**Source:** TSG CT WG4  
**Title:** Corrections on Camel4  
**Agenda item:** 8.3  
**Document for:** APPROVAL

⌘ **23.078 CR 772** ⌘ rev - ⌘ Current version: **6.5.0** ⌘

<b>Title:</b>	⌘ Correction to No_Answer handling in CAMEL_ICA_MSC2		
<b>Source:</b>	⌘ Ericsson		
<b>Work item code:</b>	⌘ Camel4	<b>Date:</b>	⌘ 27 April 2005
<b>Category:</b>	⌘ <b>A</b>	<b>Release:</b>	⌘ Rel-6
<i>Use one of the following categories:</i>		<i>Use one of the following releases:</i>	
<b>F</b> (correction)		<b>Ph2</b> (GSM Phase 2)	
<b>A</b> (corresponds to a correction in an earlier release)		<b>R96</b> (Release 1996)	
<b>B</b> (addition of feature),		<b>R97</b> (Release 1997)	
<b>C</b> (functional modification of feature)		<b>R98</b> (Release 1998)	
<b>D</b> (editorial modification)		<b>R99</b> (Release 1999)	
		<b>Rel-4</b> (Release 4)	
		<b>Rel-5</b> (Release 5)	
		<b>Rel-6</b> (Release 6)	
		<b>Rel-7</b> (Release 7)

Figure 4.88-1: Procedure CAMEL\_ICA\_MSC\_ANSWER (sheet 1)

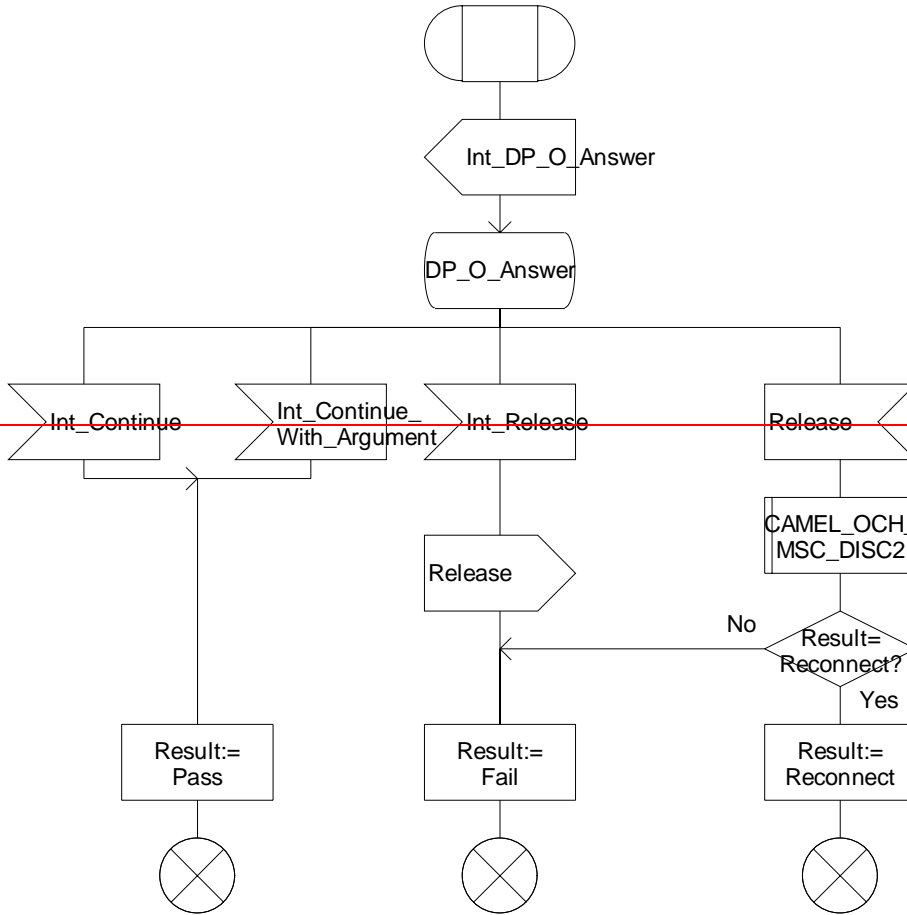
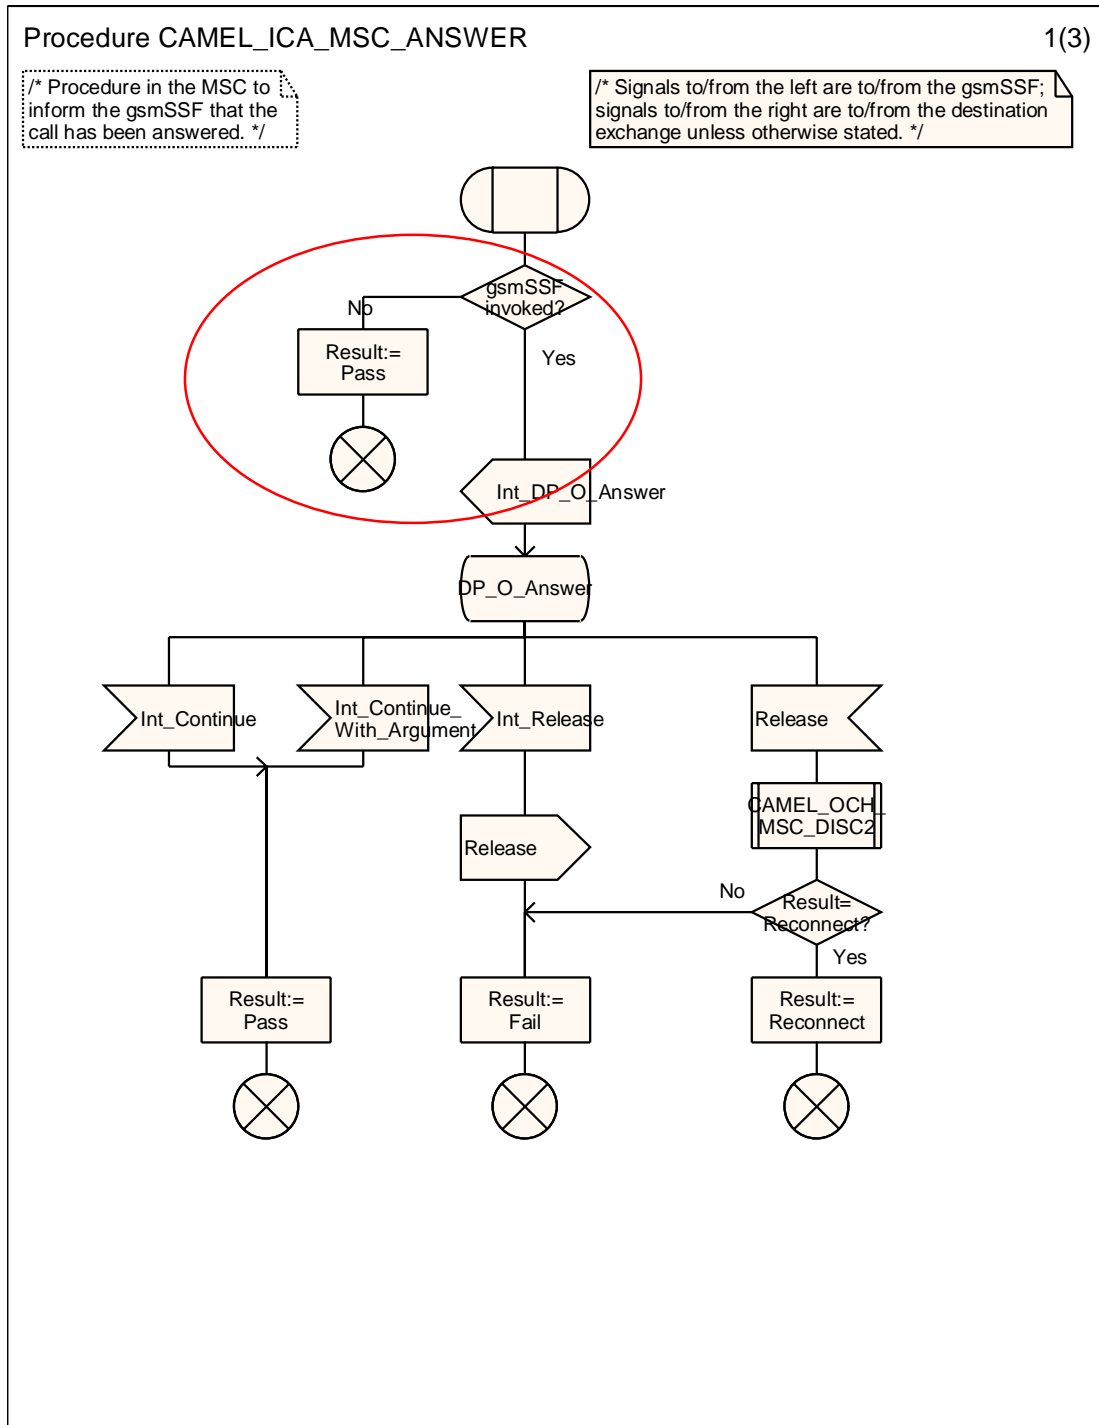
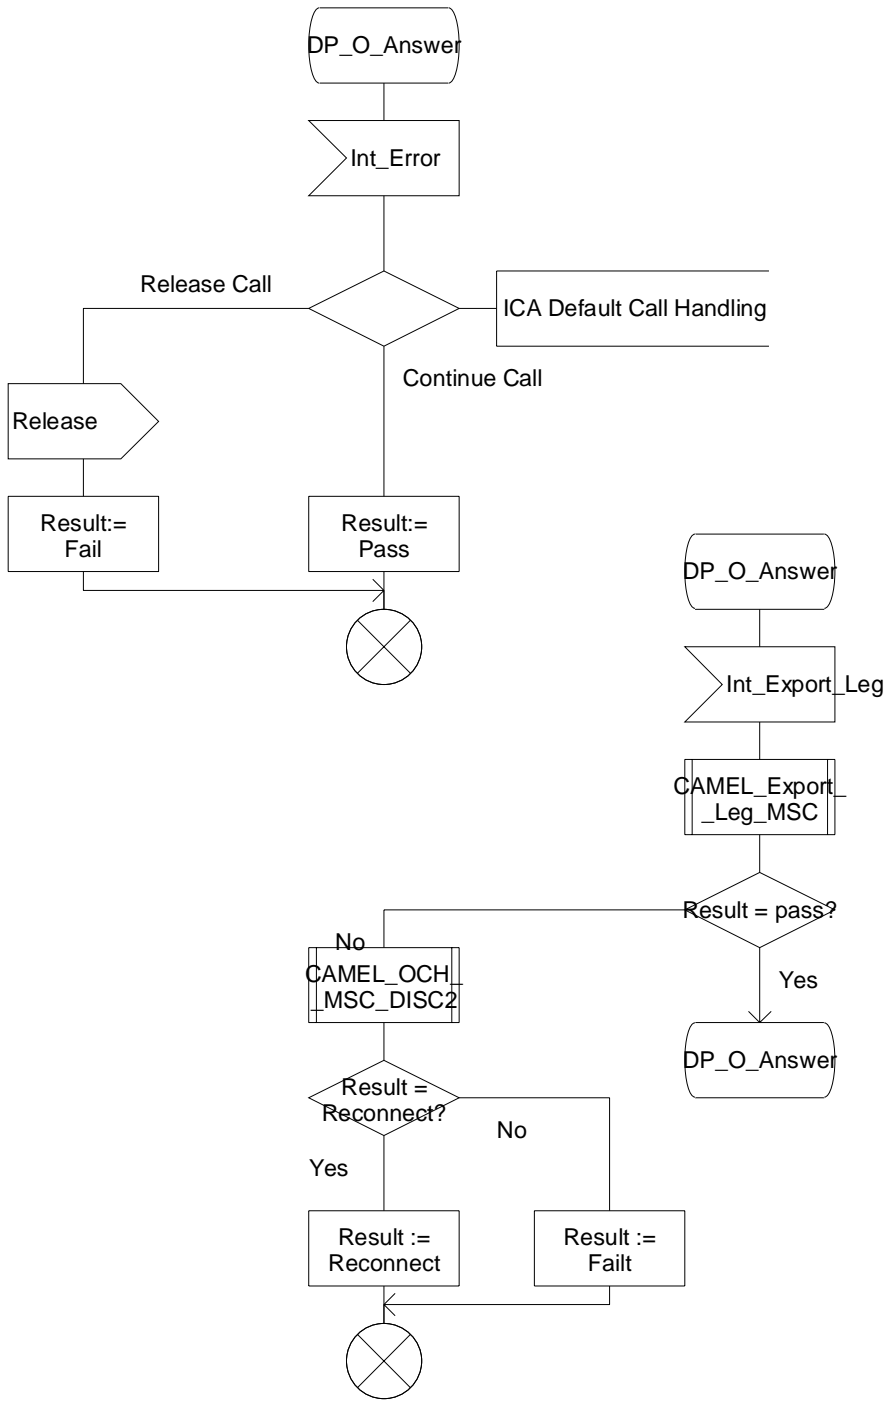
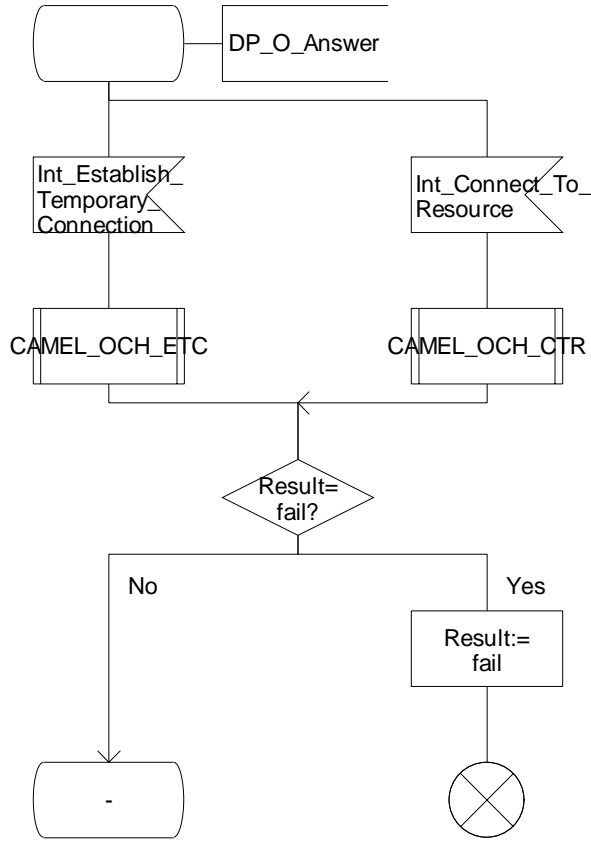
The procedures CAMEL\_ICA\_MSC\_ANSWER, CAMEL\_ICA\_MSC\_ALERTING, CAMEL\_ICA\_MSC1 and CAMEL\_ICA\_MSC2 in section 4.5.6 (Handling of gsmSCF initiated calls) need correction.

<p>CAMEL_ICA_MSC2 would actually need this check “<i>gsmSSF invoked?</i>”.</p> <p>For the same reason, the procedures CAMEL_ICA_MSC_ANSWER, CAMEL_ICA_MSC_ALERTING need the check “<i>gsmSSF invoked?</i>”.</p> <p>When Disconnect occurs on an ICA leg, then procedure CAMEL_OCH_MSC_DISC2 is called. That procedure is specified in section 4.5.2 (Handling of mobile originated calls) and contains already the check for an active gsmSSF process.</p>
<b>Summary of change:</b> ⌘	Add the check <i>check “gsmSSF invoked?”</i> to CAMEL_ICA_MSC_ANSWER, CAMEL_ICA_MSC_ALERTING, CAMEL_ICA_MSC1 and CAMEL_ICA_MSC2 in section 4.5.6 (Handling of gsmSCF initiated calls).
<b>Consequences if not approved:</b> ⌘	Unnecessary signal is sent to the gsmSSF process that may not actually exist. Implementers may expect that call events like Busy, Answer etc. can always be reported to the SCP, which would cause unexpected behaviour.

Figure 4.89-1: Procedure CAMEL\_ICA\_MSC1 (sheet 1)

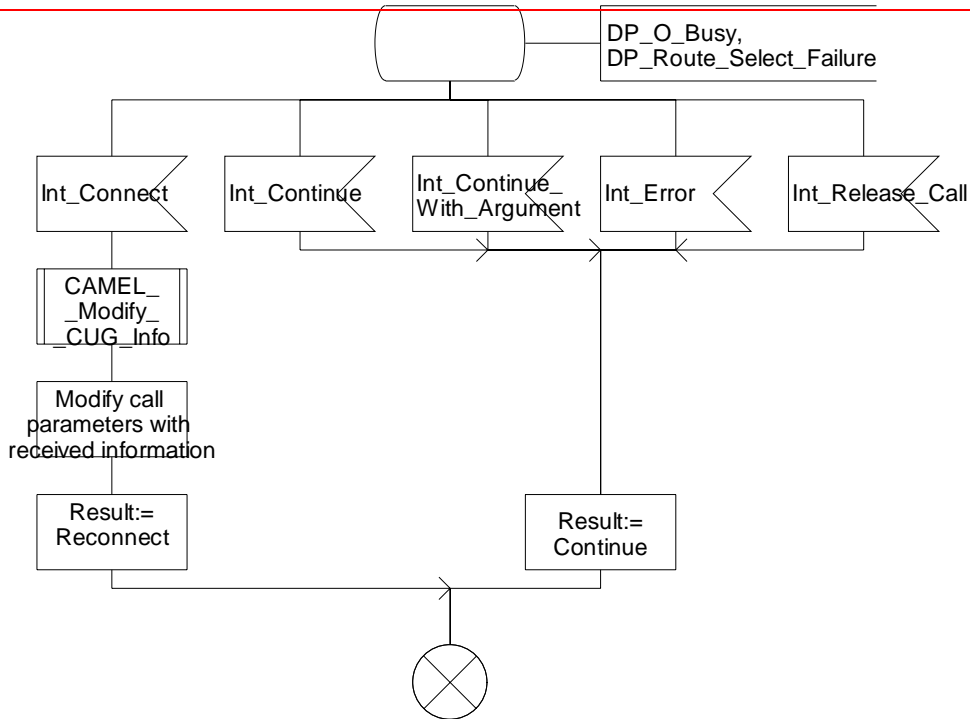
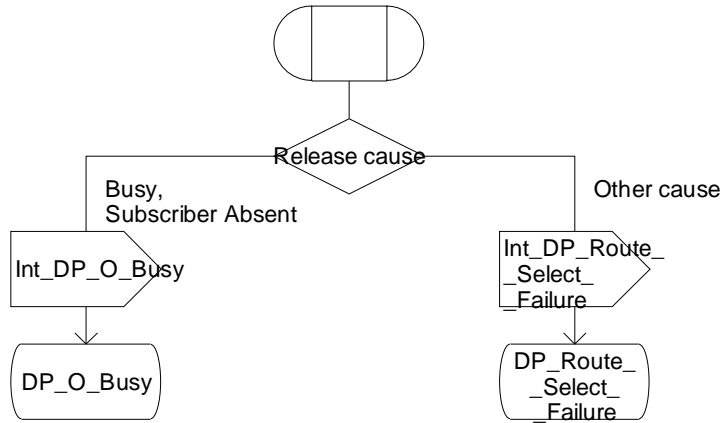
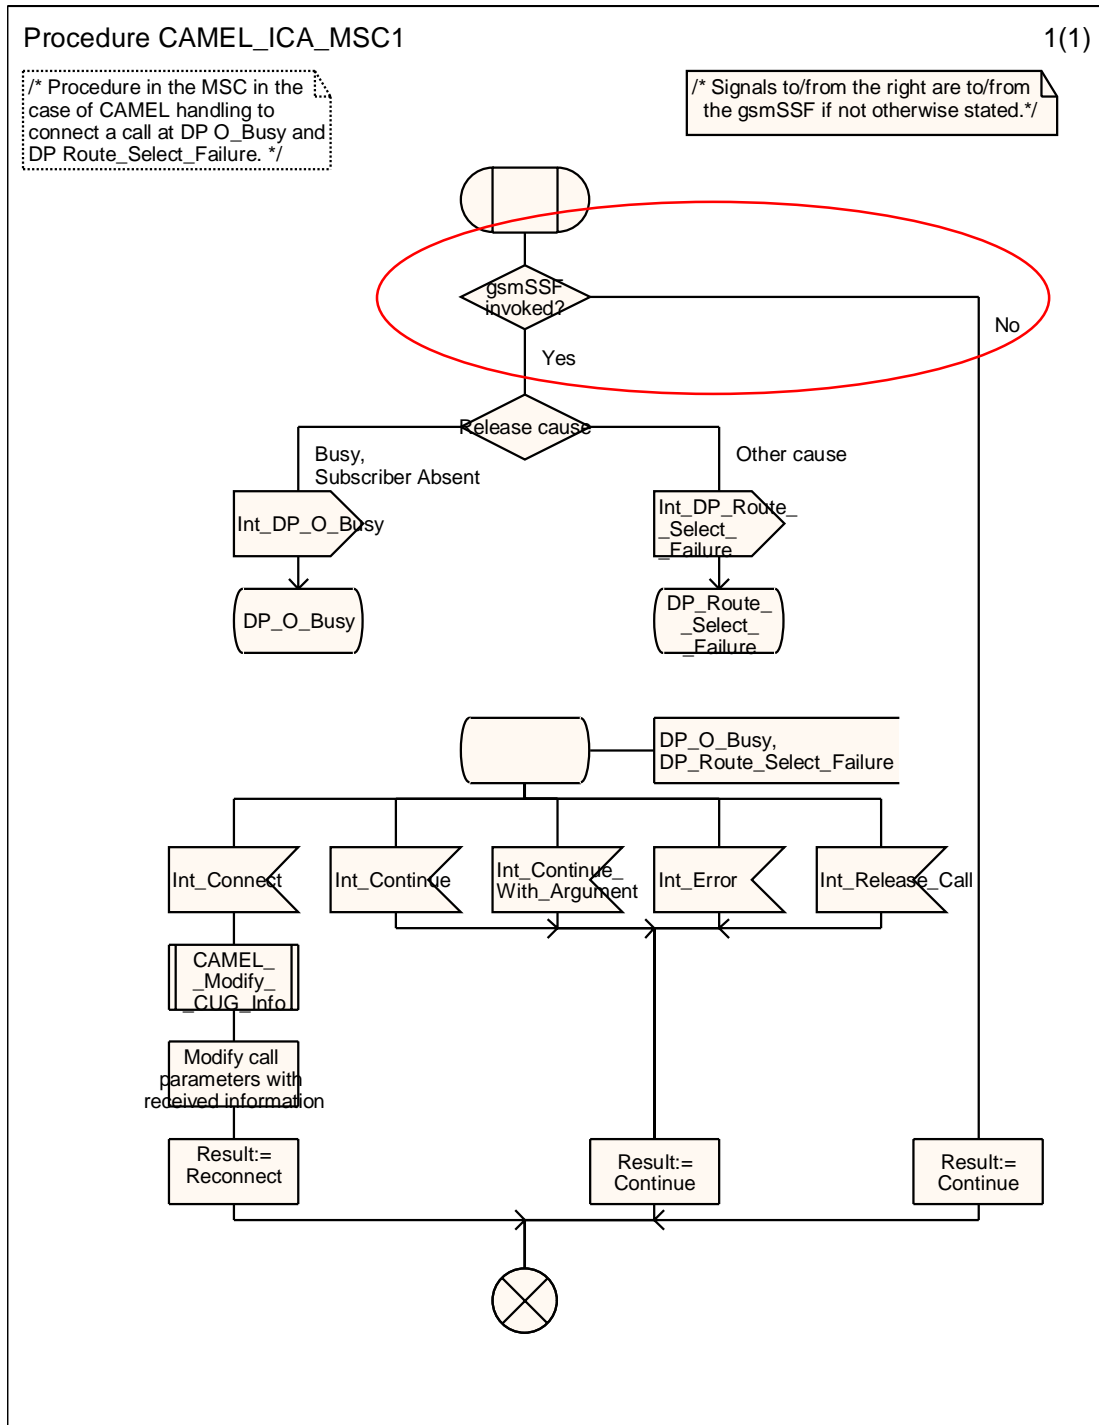
When an ICA leg is created, the gsmSCF is required to arm the call establishment failure DPs. As a result, the gsmSSF process for the ICA leg remains active during call establishment. Hence, when CAMEL\_ICA\_MSC1 or CAMEL\_ICA\_MSC2 is executed, as a result of the occurrence of a call establishment failure event, then it is not possible that there is no gsmSSF process active for that ICA leg. For that reason, procedures CAMEL\_OCH\_MSC1 and CAMEL\_OCH\_MSC2 don't check whether a gsmSSF process is active for that leg.

In the case of the ICA leg, we could, however, have the situation that the ICA leg is answered and then moved to Call Segment 1. Then later on, a follow-on call is generated for the ICA leg and the gsmSCF drops out of the call. So, there is no gsmSSF process anymore. In that case, CAMEL\_ICA\_MSC1 or
